To: T10 SAS Protocol Working Group

From: Brian Day [and George Penokie](#)

Subject: ~~SAS-2.1~~[SPL](#): 08-249 Link Layer Power Management

This proposal is a complement to 08-015 [and 08-206](#). This proposal focusses on link layer changes to support lower power modes.

Figure 121 — XL (link layer for expander logical phys) state machine (part 1)

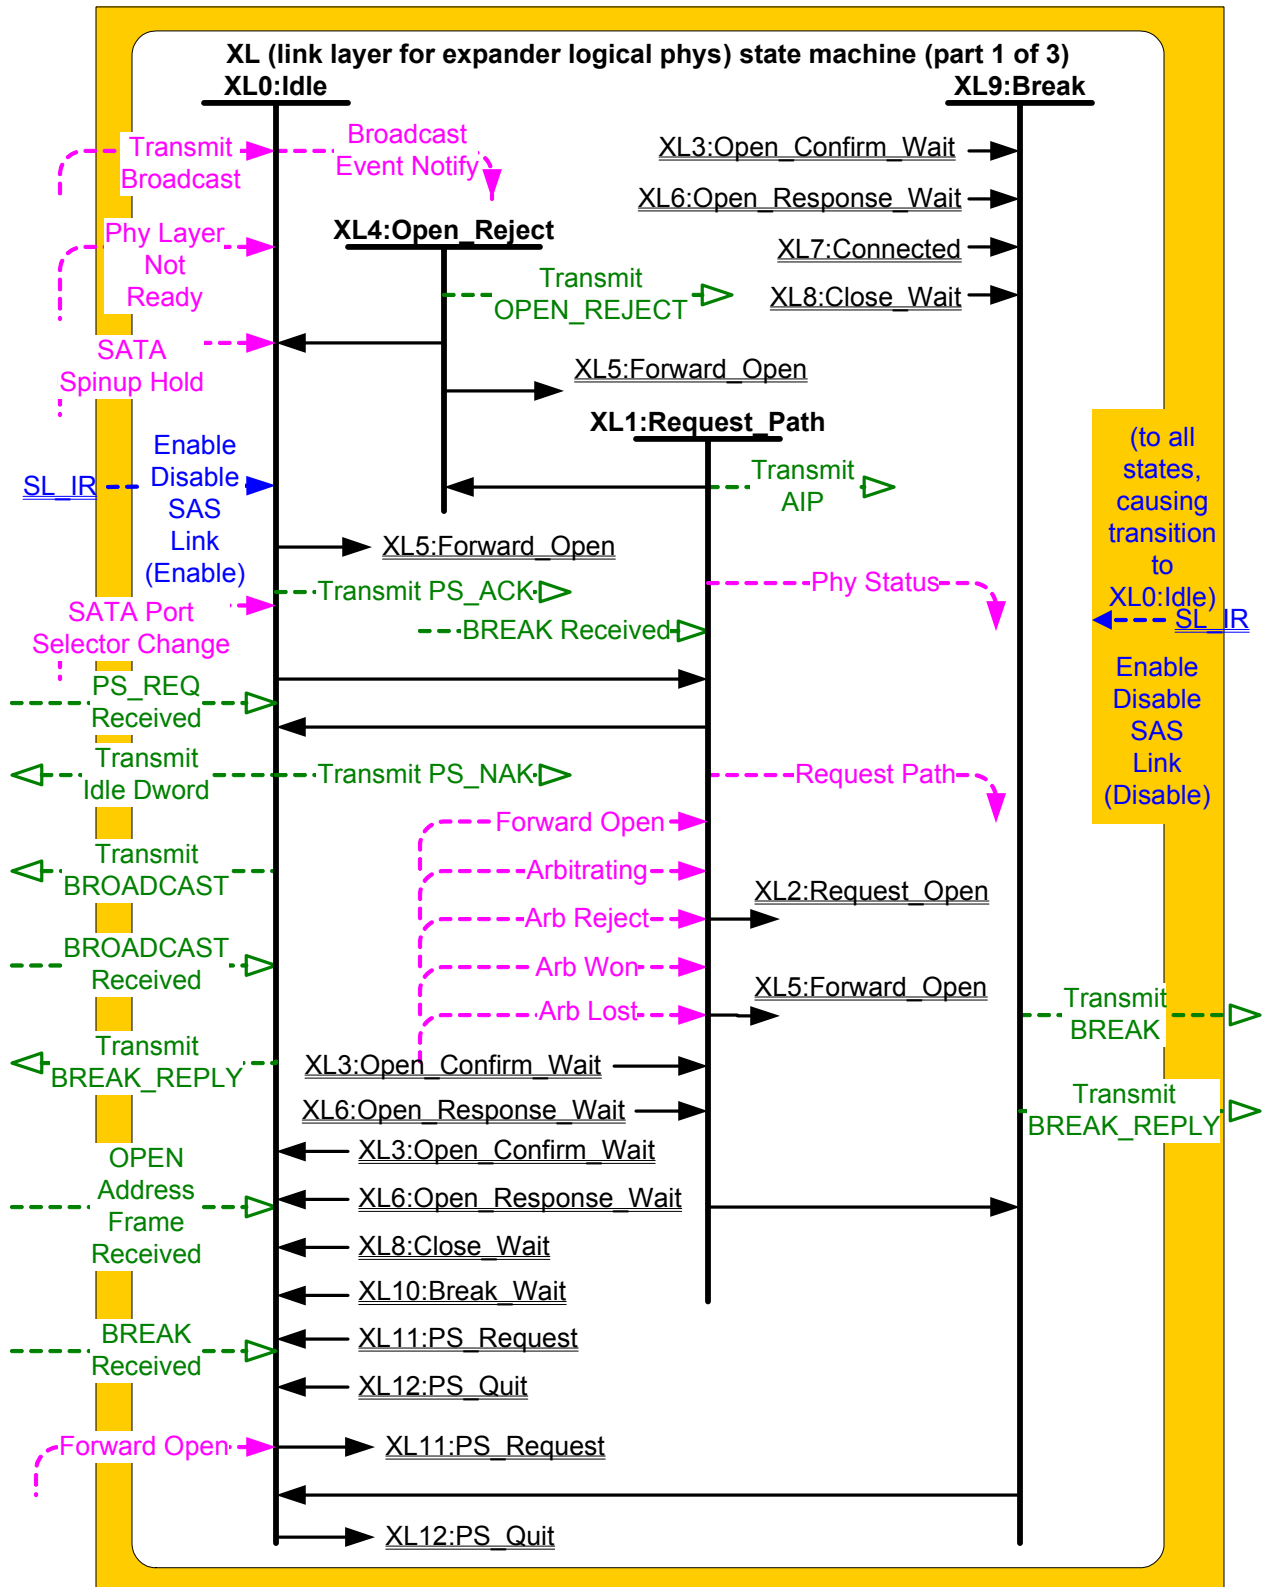
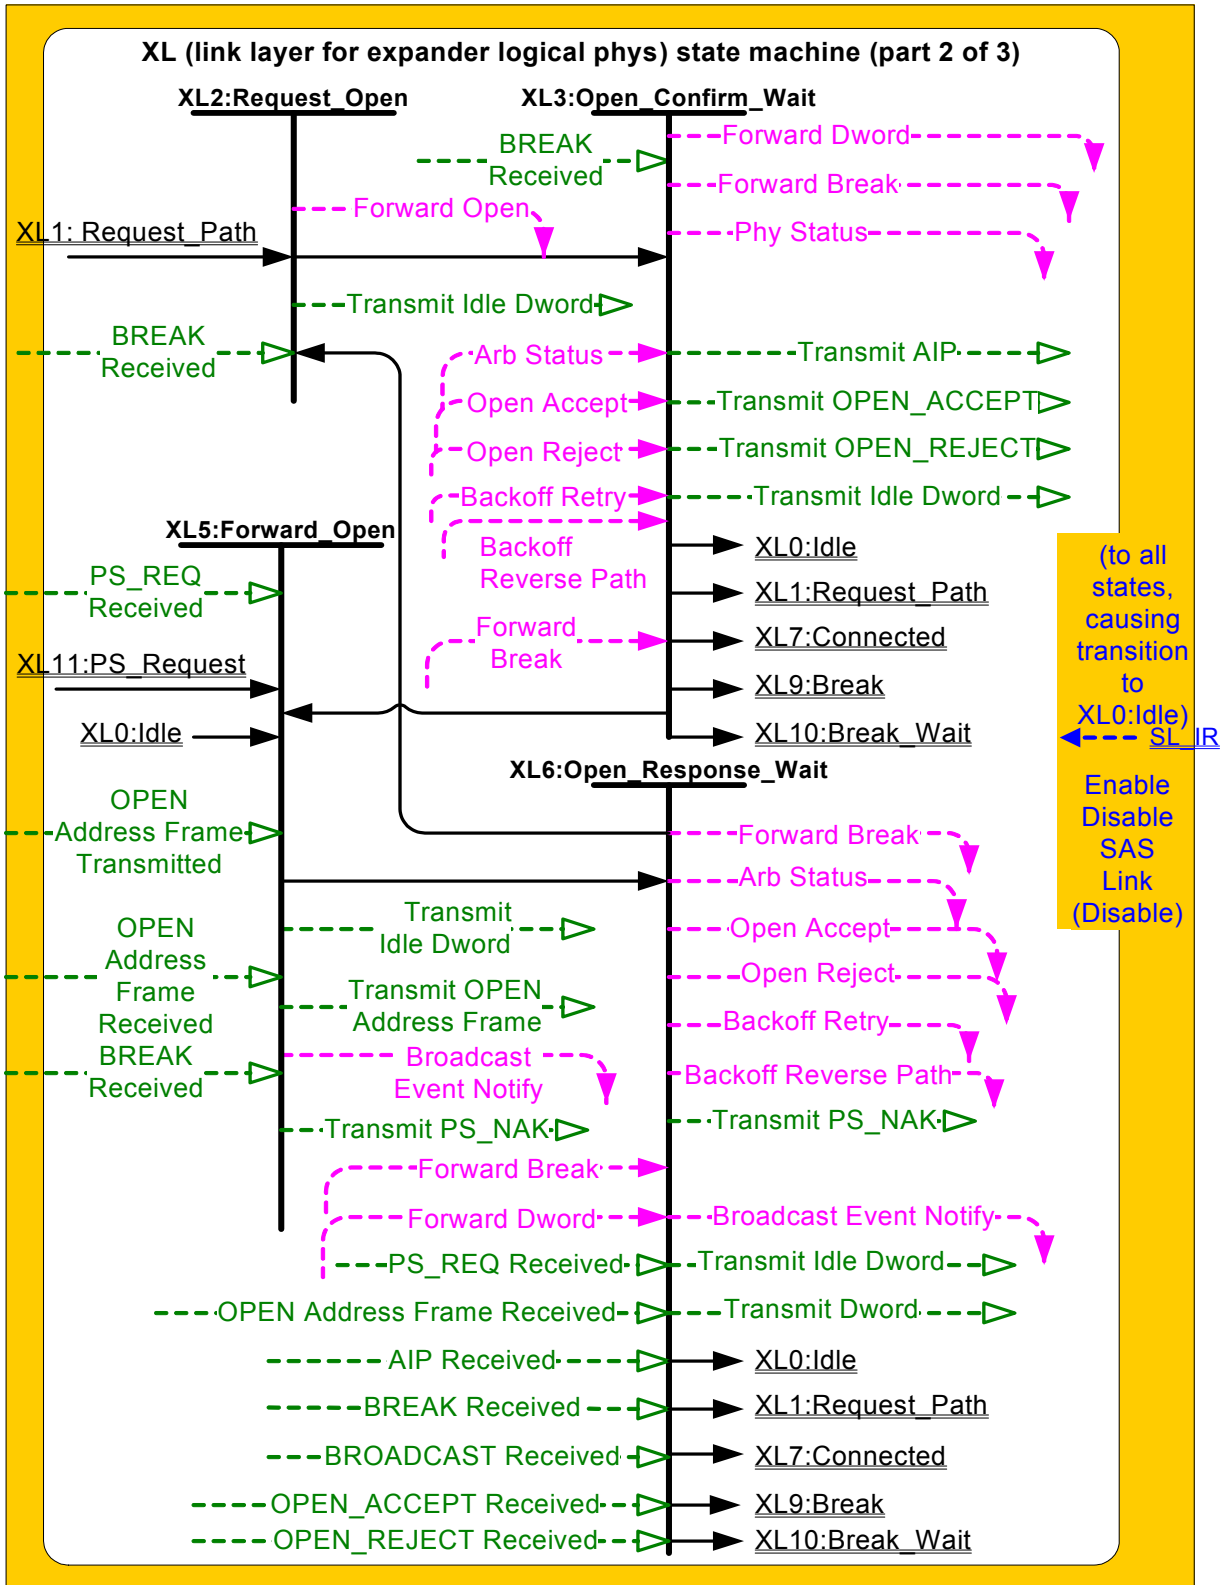
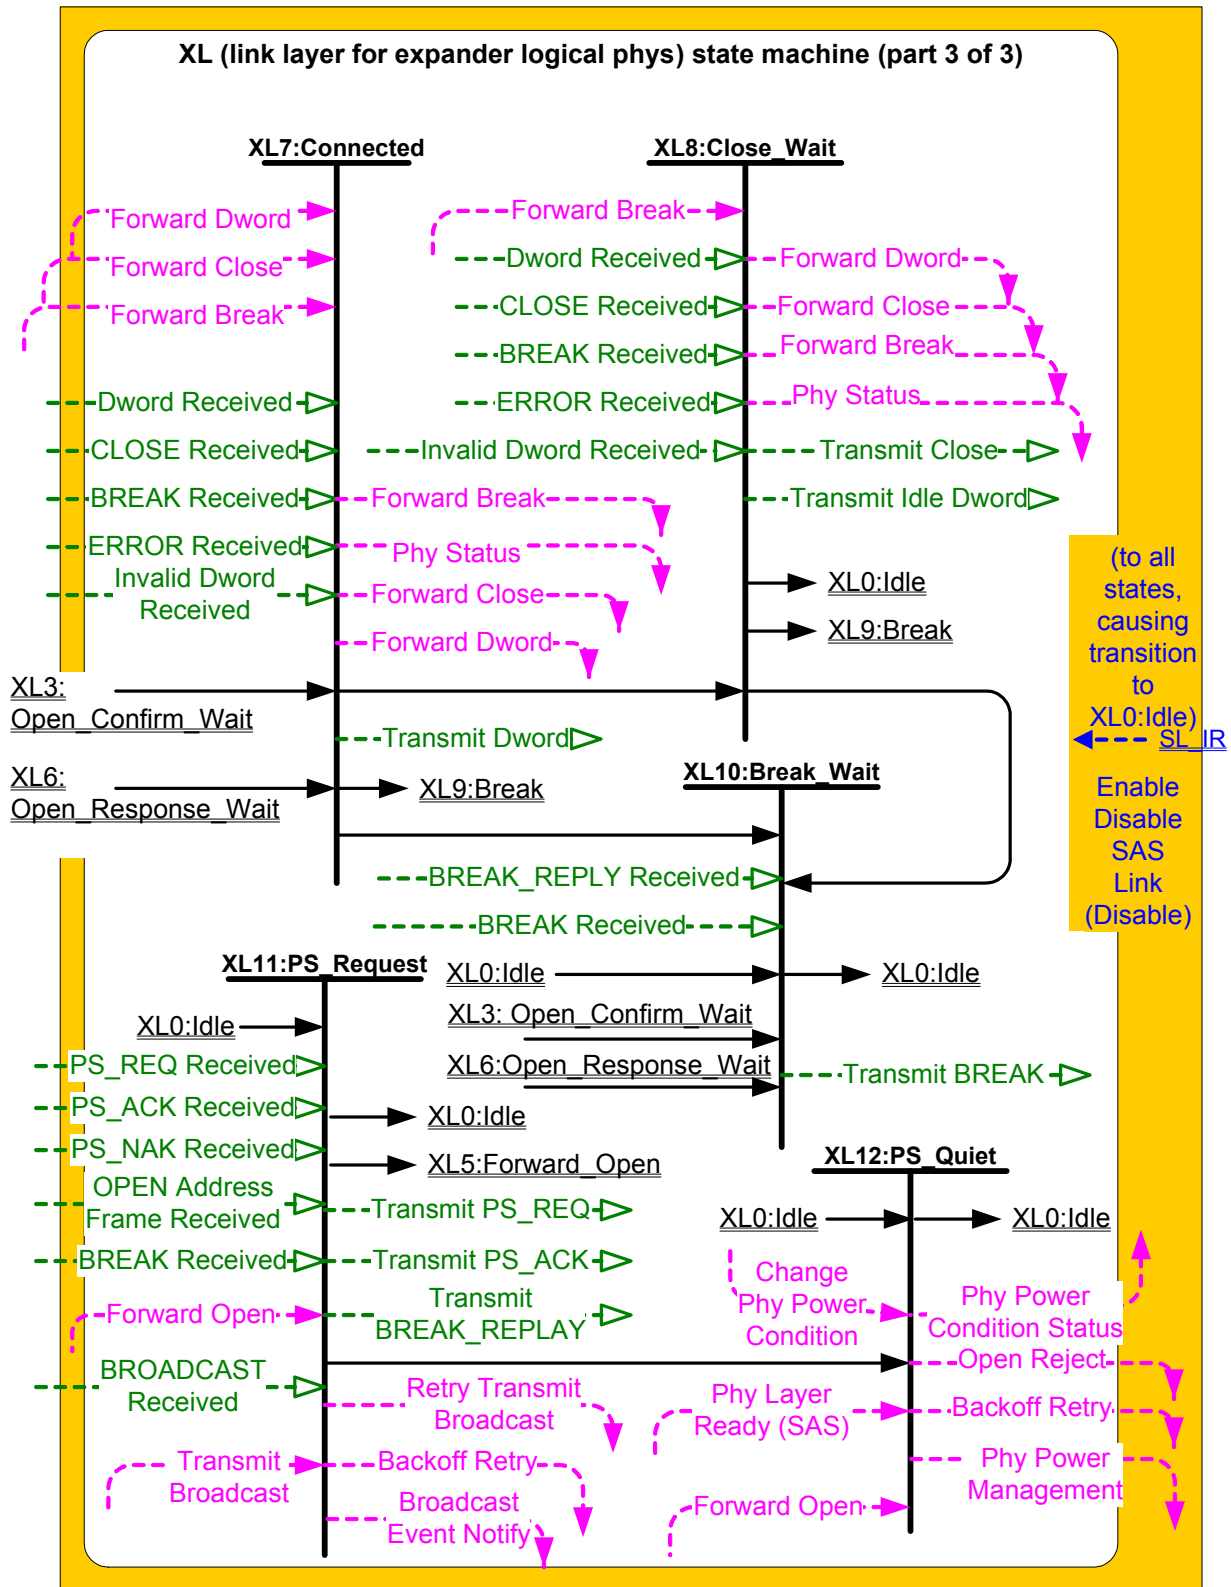
[Revision 3 - Added rules that make partial have priority over slumber. Made the SAS Address only a tie breaker in the case were the sent and received power conditions are the same. Added the changes to the XL state machine to show the power management and the port layer retry that occurs if a phy is in a low power condition and an open is attempted. Split the Accept PS_REQs state machine variable into separate Partial and Slumber versions. For the XL state machines, replaced "management application layer" with "ECM", since expanders don't have a management application layer. Added wording to handle Broadcast Received and BREAK Received in the PS_Request states.](#)

[Revision 4 - Added an exit out of PS_REQUEST on receipt of BREAK in both SL and XL. Changed power state to power condition and phy power state to phy power condition. Added wording to force power management to be disabled when link multiplexing is enabled.](#)
